RESOLUTION NO. R- 2384

A RESOLUTION OF THE CITY COUNCIL OF THE CITY OF KIRKLAND APPROVING THE ISSUANCE OF A FINAL PLANNED UNIT DEVELOPMENT AS APPLIED FOR IN DEPARTMENT OF COMMUNITY DEVELOPMENT FILE NO. PUD-76-41(P), BY VILLAGE UNIVERSAL OF WASHINGTON TO CONSTRUCT A 26-UNIT CONDOMINIUM DEVELOPMENT OF "SUNSET CONDOMINIUMS" BEING WITHIN A WATERFRONT DISTRICT I ZONE, AND SETTING FORTH CONDITIONS TO WHICH SUCH FINAL PLANNED UNIT DEVELOPMENT PERMIT SHALL BE SUBJECT.

**ADVISORY REPORT**  
FINDINGS, CONCLUSIONS AND RECOMMENDATIONS

FILE NUMBER SDP-PUD-76-41(P) FINAL  
 APPLICANT VILLAGE UNIVERSAL OF WASHINGTON  
 PROPERTY LOCATION South of 733 Lake St. So.  
 SUBJECT Applic. for FINAL Planned Unit Development and Substantial Development Permit for "SUNSET CONDOMINIUMS"  
 HEARING/MEETING DATE \_\_\_\_\_  
 BEFORE \_\_\_\_\_

EXHIBIT "A"  
 SITE PLAN/VICINITY MAP  
 SDP-PUD-76-41(P) Final  
 Sunset Condominiums

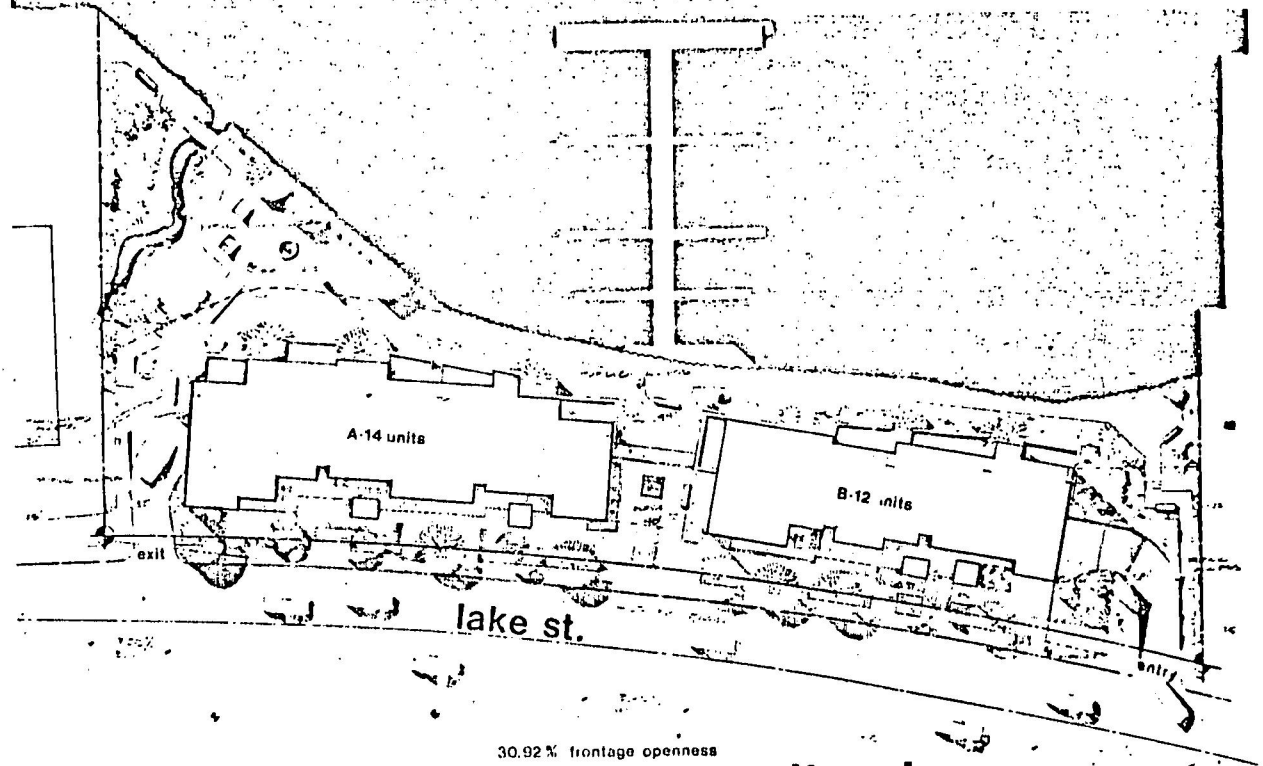
- A. 4. (Cont'd)  
Kirkland harmless for any claims for injury or damages resulting from improper maintenance of that area. Further, the applicant shall be required to submit an exhibit which indicates the physical areas where public access is being permitted on the subject property. Further, Exhibits "A" and "K" shall be modified to include a 6 foot wide hard surface ramp in the north property line setback from the location of the proposed entry driveway to the waterfront trail area. This shall be in addition to the public pathway as indicated on that exhibit.

8. Pursuant to Resolution No. 2359, the following are relevant:
- a. The applicant shall be required to modify Exhibit "A" to comply with the Shoreline Hearing Board Order of Dismissal. With this addition, the proposed public access area will be accessible for handicapped and disabled persons.
- b. The Park Department has recommended that the pedestrian trails be constructed out of aggregate concrete. This material was recommended due to its resistance to wave action and erosion plus the previous use of gravel, cinders, and asphalt in City waterfront parks have not been functionally satisfactory. This material has been used with the Moss Bay Marina (Hadley project).

- b. That the applicant shall modify Exhibits "A", "H", "I" and "J" to include a 6 foot wide aggregate concrete pathway from the entry driveway to the north property line setback area to the water's edge pedestrian way which is in addition to the public access already indicated there and is consistent with the Order of Dismissal from the Shoreline Hearing Board of SHB NO. 222.
